SUTHERLAND SHIRE COUNCIL ADDENDUM ASSESSMENT REPORT

Panel Reference	2017SSH019
DA Number	DA17/0467
LGA	Sutherland Shire
Proposed Development:	Refurbishment and restoration of Heathcote Hall, construction of 35 townhouses and 20 apartments, associated landscape works and 56 lot strata subdivision
Street Address:	Lot 1 & 2 DP 725184 (No. 1-21) Dillwynnia Grove, Heathcote
Applicant/Owner:	Ink Architects Pty Ltd
Date of DA lodgement	28 April 2017
Number of Submissions:	55 groups/individuals from formal post meeting notification period (November 2018), and 3 groups/individuals from May/June 2019 notification
Recommendation:	Refusal
Regional Development Criteria (Schedule 7 of the SEPP (State and Regional Development) 2011	Schedule 4A of the Act (in accordance with current version of the EP&A Act at the time of lodgement)
List of all relevant s4.15 (1)(a) matters	<ul style="list-style-type: none"> • State Environmental Planning Policy 55 – Remediation of Land • State Environmental Planning Policy 65 – Design Quality of Residential Apartment Development • Heritage Act 1977 • Rural Fires Act 1997 • Sutherland Shire Local Environmental Plan 2015 • Sutherland Shire Development Control Plan

Figure 6 CMP development zones overlaid on proposed site layout

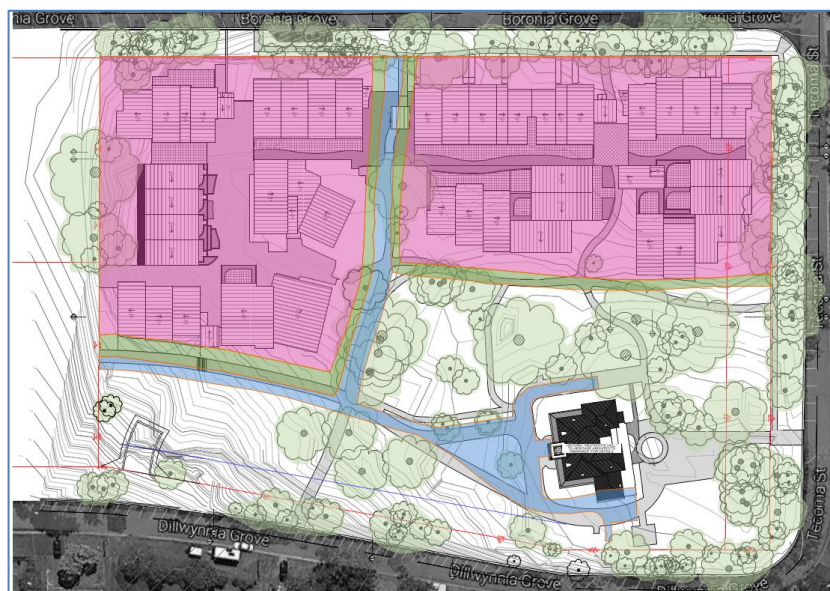
Comment: The Heritage Council has issued revised General Terms of Approval dated 27 June 2019, indicating that the amended proposal has satisfied this matter.

In response to the deferred matter regarding the development and setback zones, the applicant has also provided a plan identifying the conservation zones, former carriageway, buffers and areas where development is permitted in accordance with the CMP, see Figure 6 below.

Figure 10 Height Plane of Building B showing extent of non-compliance (as per Plan DA10HP Issue C)

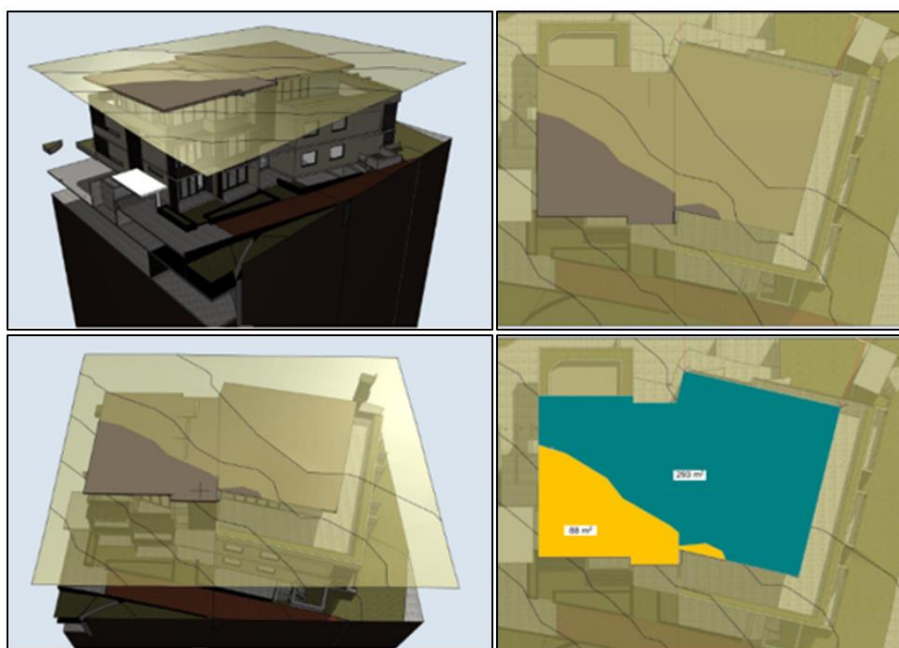
According to the applicant, Figure 10 demonstrates of the 381m² roof area, 88m² or 23% of this area is over the 8.5m building height plane.

A comparison of the current plans and the plans presented to the SSPP on 28 June 2018, indicate that the second floor plan/layout of Building B has not changed, however the roof has been extended towards the south and east, increasing the apparent bulk of Building B, as seen in Figure 11 and Figure 12 below.

Figure 13 Western view of the site, with the residential flat buildings identified in red.

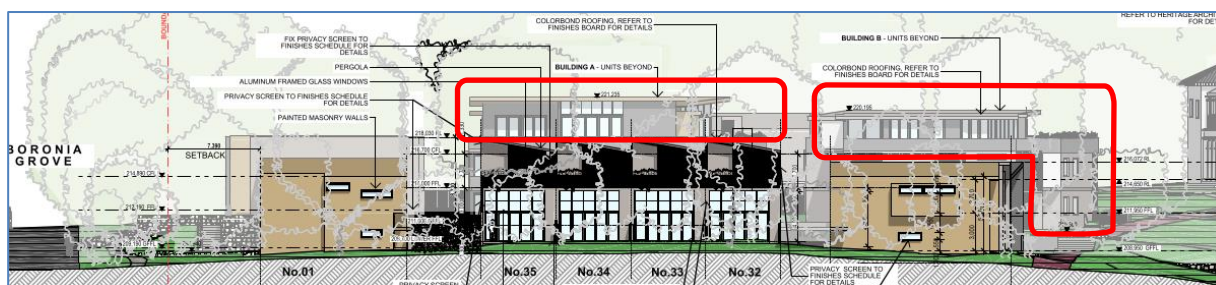
The height of each of the proposed residential flat buildings has not adequately addressed nor resolved the visual intrusion upon the locality and adjoining properties as demonstrated in Figure 13 and Figure 14 below, as per Clause 4.3 (1)(c) and (d) of the SSLEP 2015. The residential flat buildings will be

visible in particular from the west and south. The applicant has failed to minimise the visual intrusion in response to the Deferred Matters.

Figure 14 Southern view of Building B (identified in red) and Building A identified in blue

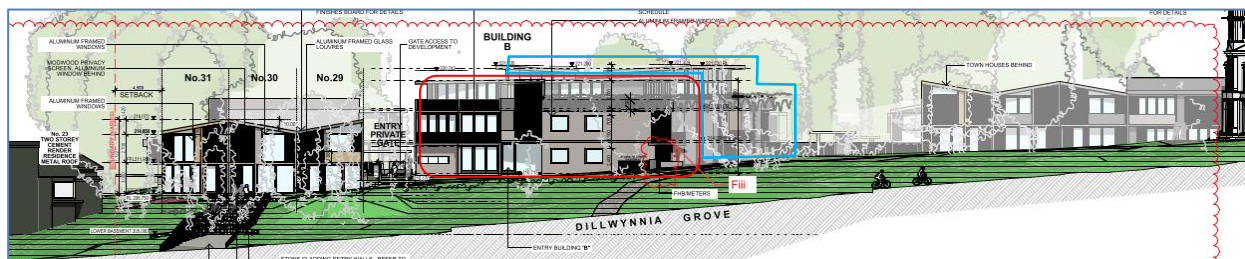
As a consequence of the proposed height of both Building A and B, the development does not address nor satisfy Clause 4.3(1)(a) of the SSLEP 2015.
